SERVICE BULLETIN

COLLINS RADIO COMPANY

PM-2 SERVICE BULLETIN NO. 1

PM-2 LIGHTWEIGHT AC POWER SUPPLY FOR KWM-2/2A TRANSCEIVER
SERVICE BULLETIN NO. 1
EXTENSION OF DESIGN SPECIFICATIONS FOR INPUT VOLTAGE LIMITS

PM-2 Chassis Frame With TB1 Removed, Partial Bottom View
Figure 1

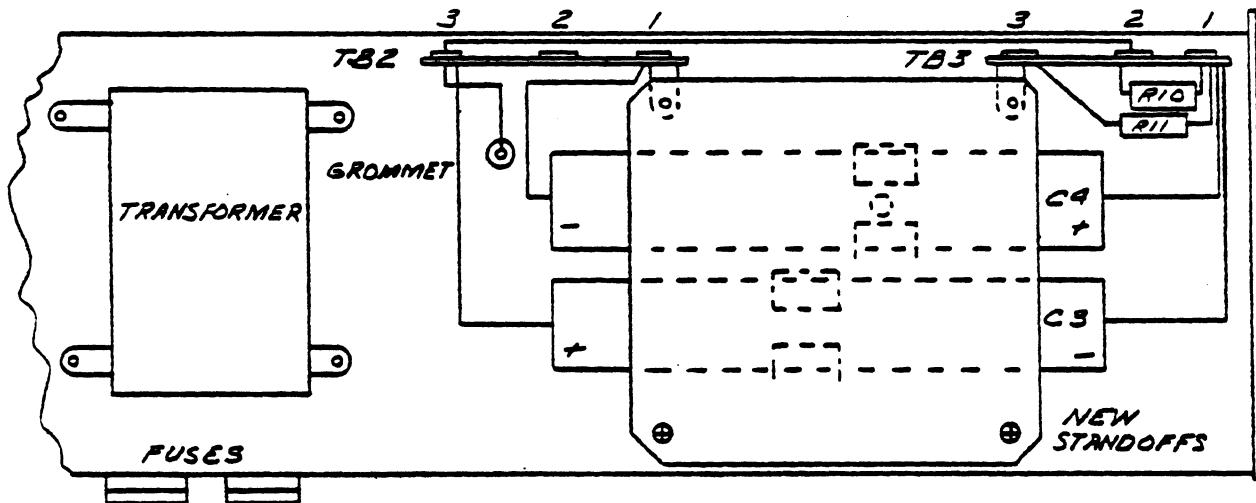
4. Drill the three holes in chassis as shown in figure 1.
5. Fasten the four clips (139-3171-00) in place with two machine screws (343-0132-00) and nuts (313-0043-00) as shown in figures 2 and 3. Insert the screws in the two smaller new holes with a clip on each side of the chassis.

PM-2, Partial Top View
Figure 2

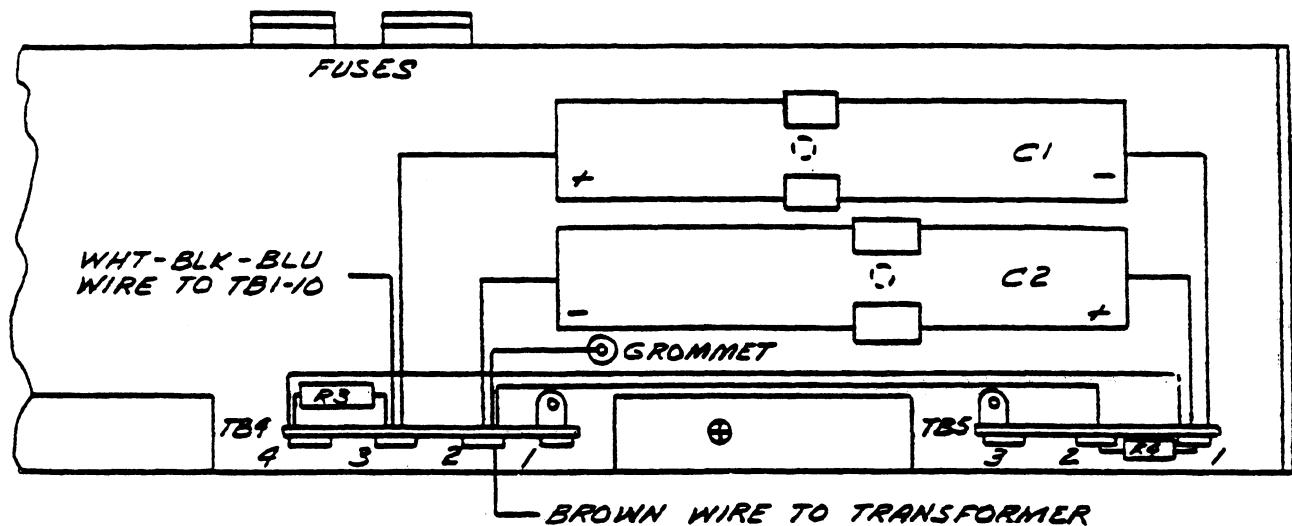
13. Add 270K resistors R3, R4, R10, R11 (745-3454-00) as shown in figures 2 and 3.
14. Remove and discard 20- μ f capacitors C1, C2, C3, and C4 located on back side of terminal board TB1.

23. Sleeve with insulation (152-1351-00) the leads of the four newly installed capacitors and connect as shown in figures 2 and 3. **CHECK POLARITY MARKINGS.**

PM-2 With TB1 in Place, Partial Bottom View
Figure 3

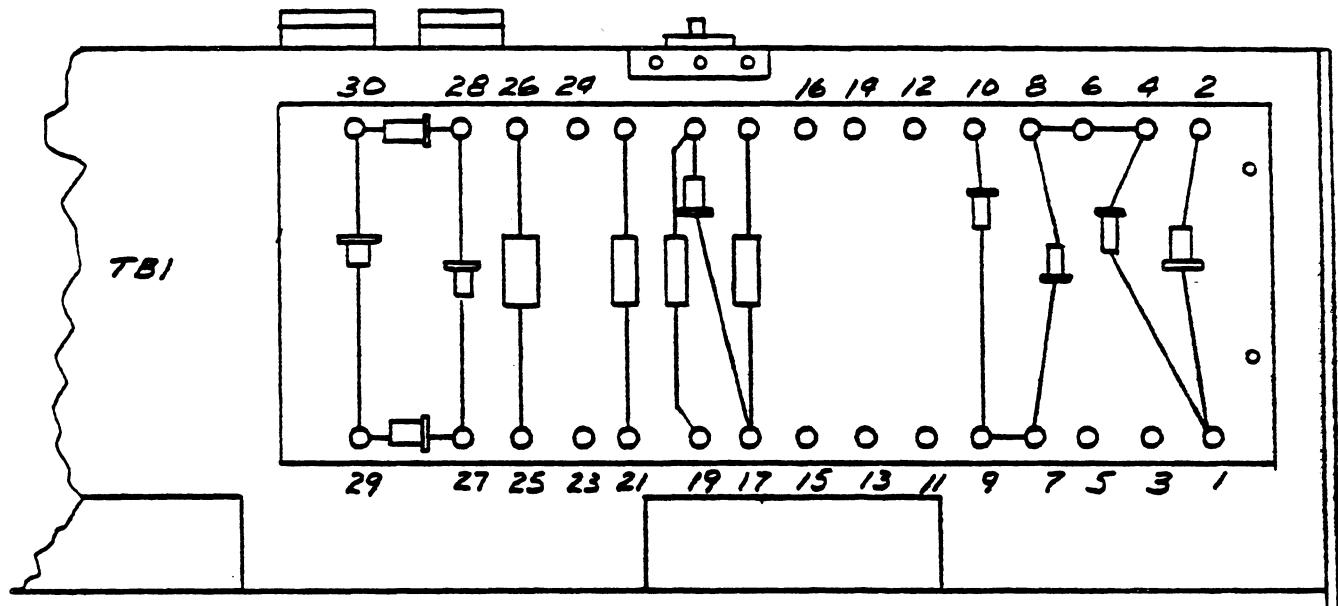
6. Insert rubber grommet (201-1040-00) in the larger of the three newly drilled holes.
7. Add 4-lug terminal strip TB4 (306-0698-00) on the bottom side of the chassis securing with rear mounting screw of transformer T1 that is nearest speaker. See figure 3. The hole in the mounting tab may have to be enlarged slightly to allow insertion of the mounting screw.

8. Add 3-lug terminal strip TB5 (306-0587-00) on the bottom side of the chassis securing with front mounting screw of speaker that is nearest outside of chassis. See figure 3.

19. Disconnect brown wire from terminal 5 on TB1 and connect to terminal 2 of TB4. See figures 3, 4, and 5.
20. Add white-black-blue wire (439-1810-00) from terminal 10 on TB1 to terminal 3 of TB4.

PM-2 With TB1 in Place, Partial Bottom View
Figure 4

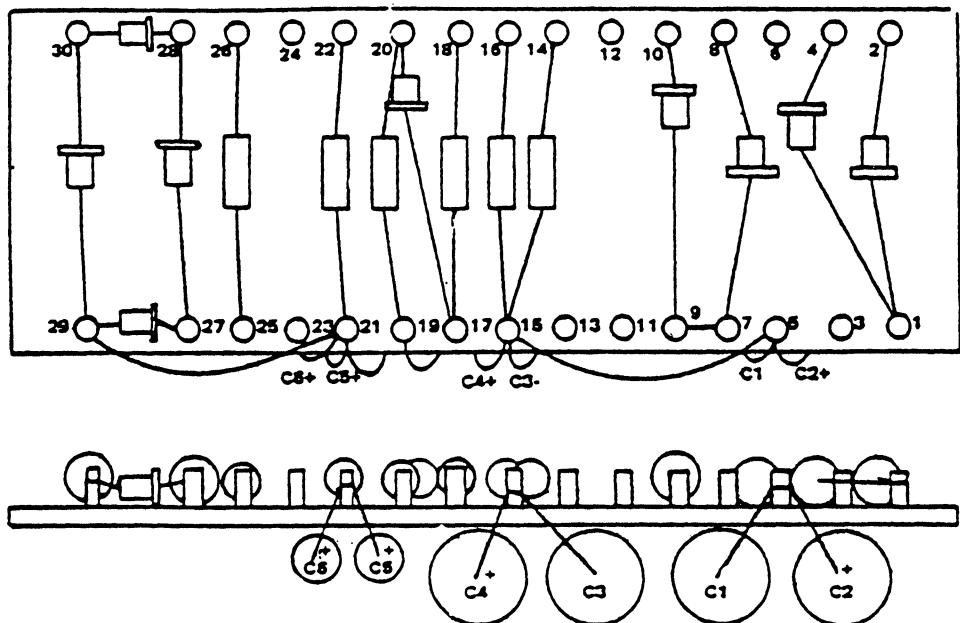
15. Remove and discard old 470K resistors R3 and R4 located on front side of terminal board TB1.
16. Remove bus wire connected between terminals 10 and 14 on TB1. See figures 4 and 5 for TB1 terminal designations.

PM-2 TB1 Partial Bottom and Edge View
Figure 5

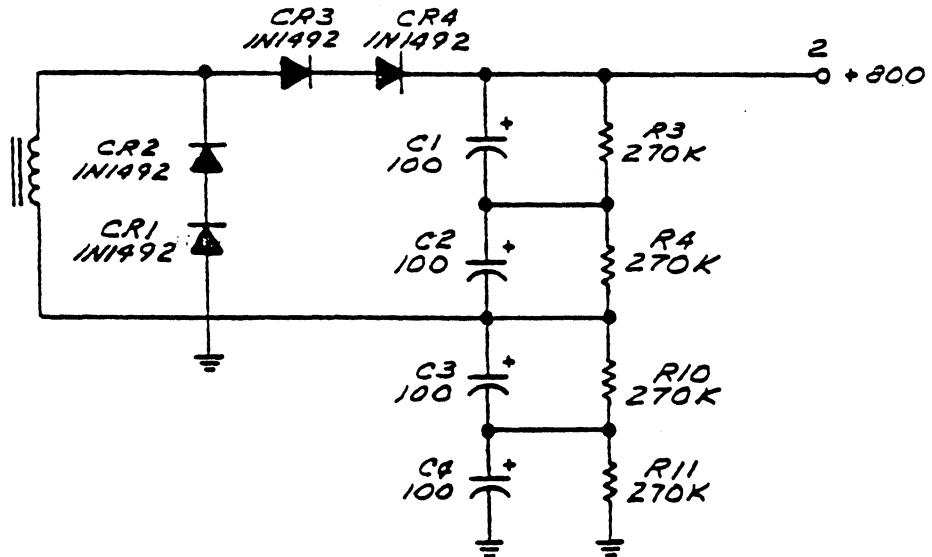
1. To change to a slightly longer standoff post than the one listed in the original modification kit.
2. To add a reference to the new edition of the PM-2 instruction sheet.
3. Add new illustration (figure 5, original figure 5 is changed to figure 6).
